**CITY OF SAN JUAN**  
**LIFT STATION No. 6 RELOCATION PROJECT**  
**RFB NO. 25-005-04-09**  
**ADDENDUM NO. 5**

**Addendum Date: April 15, 2025**

PROJ. NO.: 23.016  
DESIGNED: RS  
DRAWN: CF/JP  
DRAWING NUMBER S-2  
SHEET NUMBER 56 OF 72

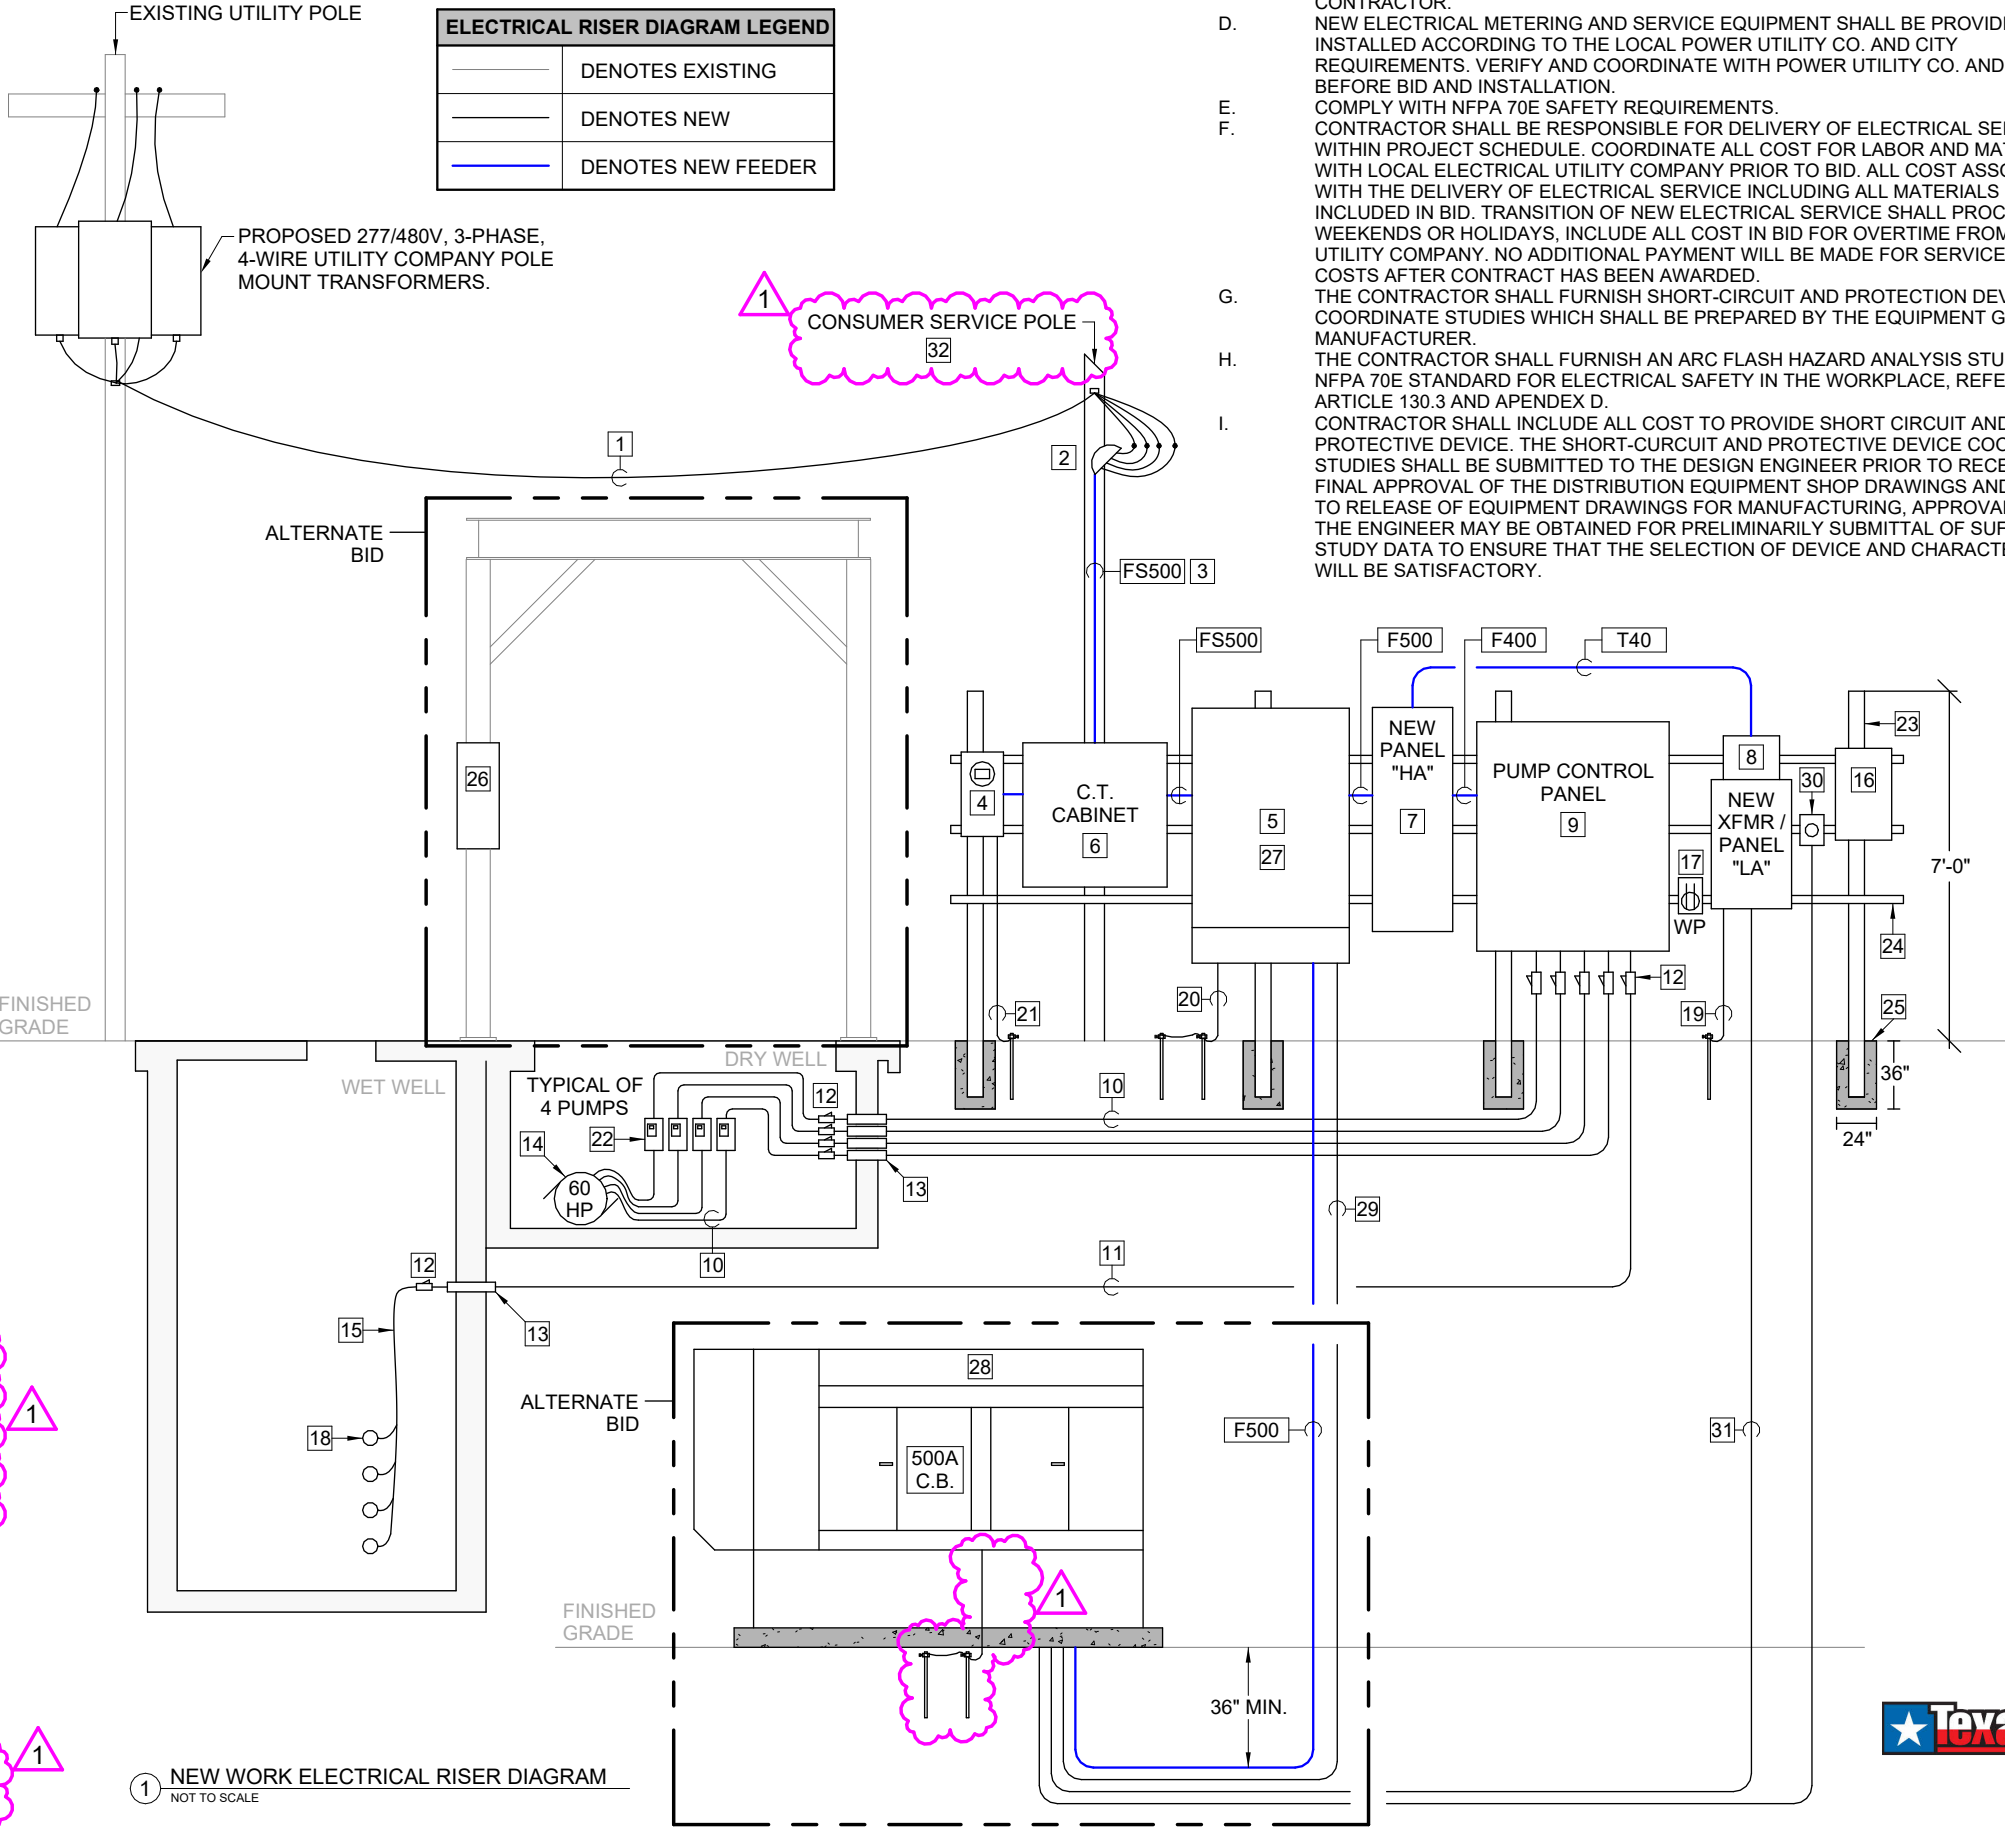
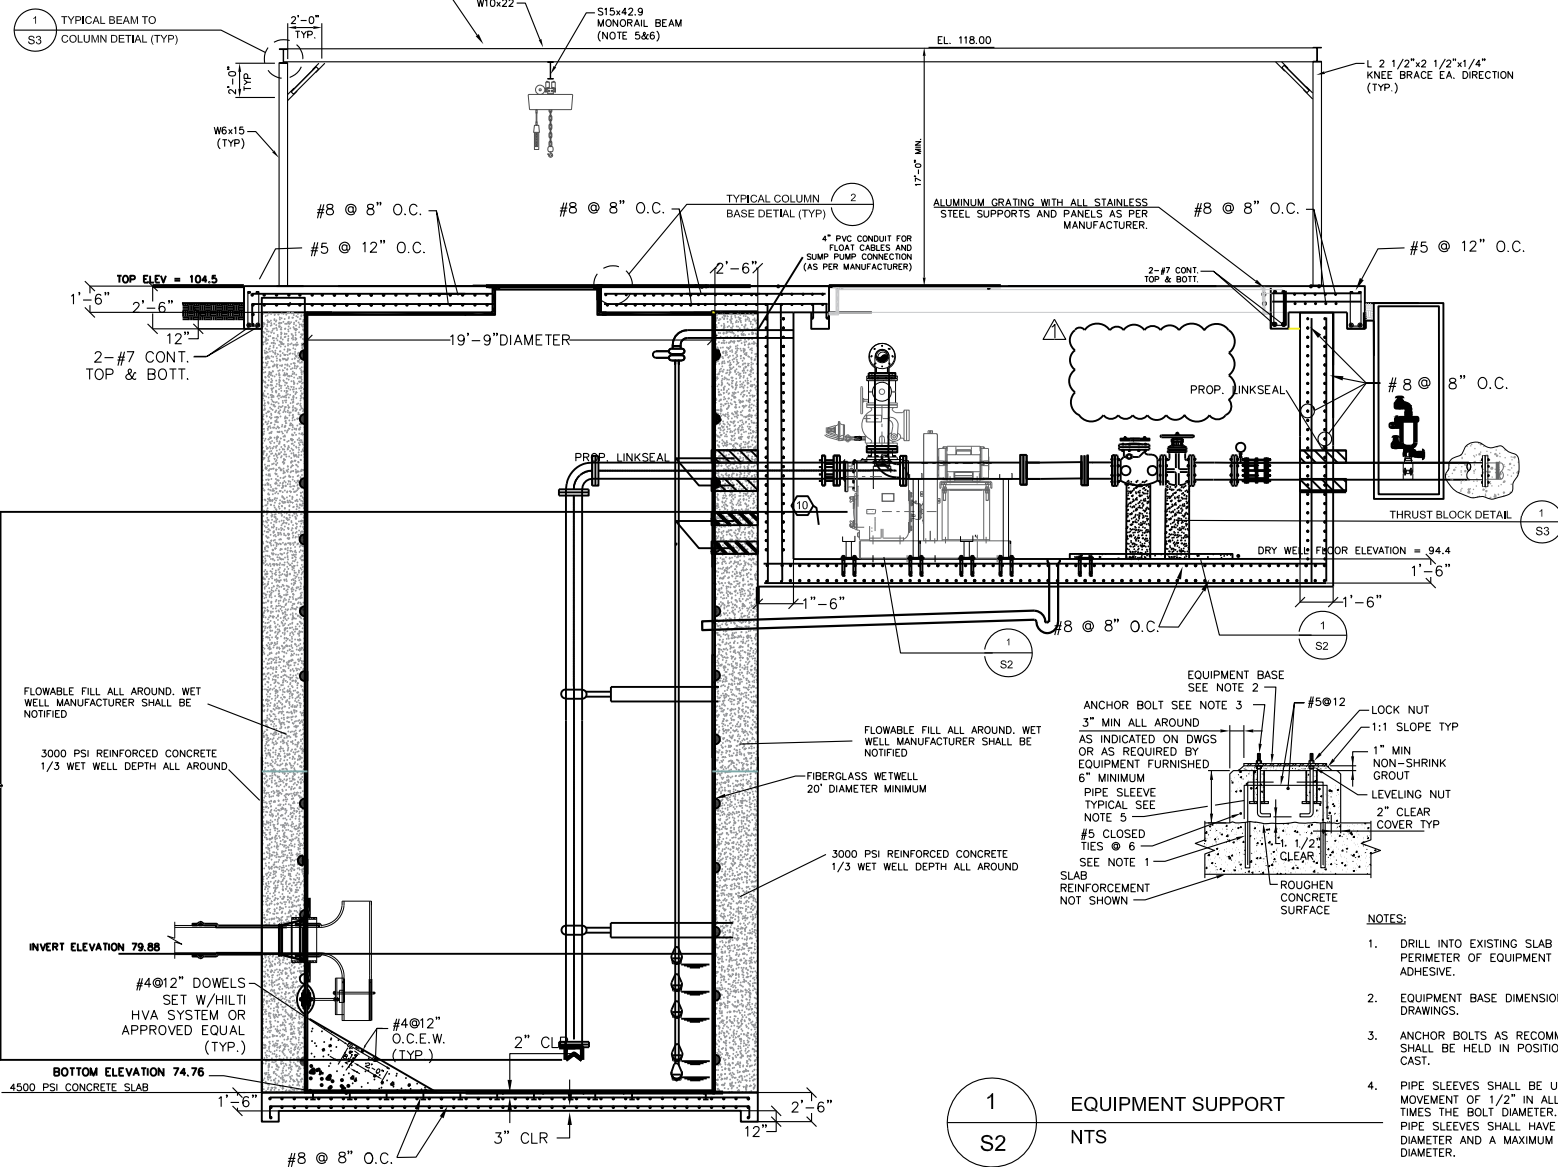
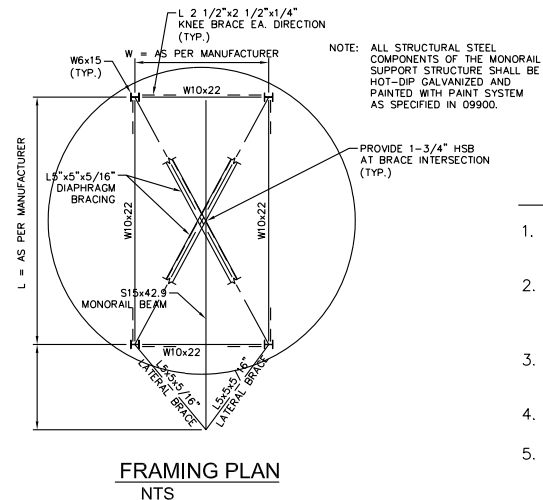
11. Sheet S-2 shows framing plan, but scale for this plan is missing we provided takeoff for this item in sheet S-1 on wet well, please clarify.
- This detail is for the use of a monorail crane; which is not being utilized for this project. The project requires an overhead bridge crane. All crane design shall be provided to Engineer from Manufacturer in submittals and requires an Engineer Plan signed and sealed for any and all types of cranes for this project.

12. Sheet S-2, shows slab in top and bottom of wet well, but scope of this slab is missing in plans, we assumed an area for this item, please clarify.
- Dimensions of Top Slab are given in Sheet L03.

13. Sheet S-2, shows flowable fill all around wet well, but thickness of this fill is missing in drawings, we assumed it 1'-6", please clarify.
- Please see Sheet L04 for dimension of the thickness of the flowable fill and reinforced concrete around the wet well.

14. Sheet S-2, shows 3000 psi reinforced concrete, but thickness of this concrete is missing in drawings, we assumed it 1'-6", please clarify.
- Please see Sheet L04 for dimension of the thickness of the flowable fill and reinforced concrete around the wet well.

15. Sheet S-2, details 1/S2 shows equipment support detail, but size and scope of this item is missing in plans, we assumed a lump sum price for this item, please clarify.

- 1/S2 is for pump support and is as per manufacturer requirements for support of chosen self priming pumps. The manufacturer shall provide their support for their pump in submittals.
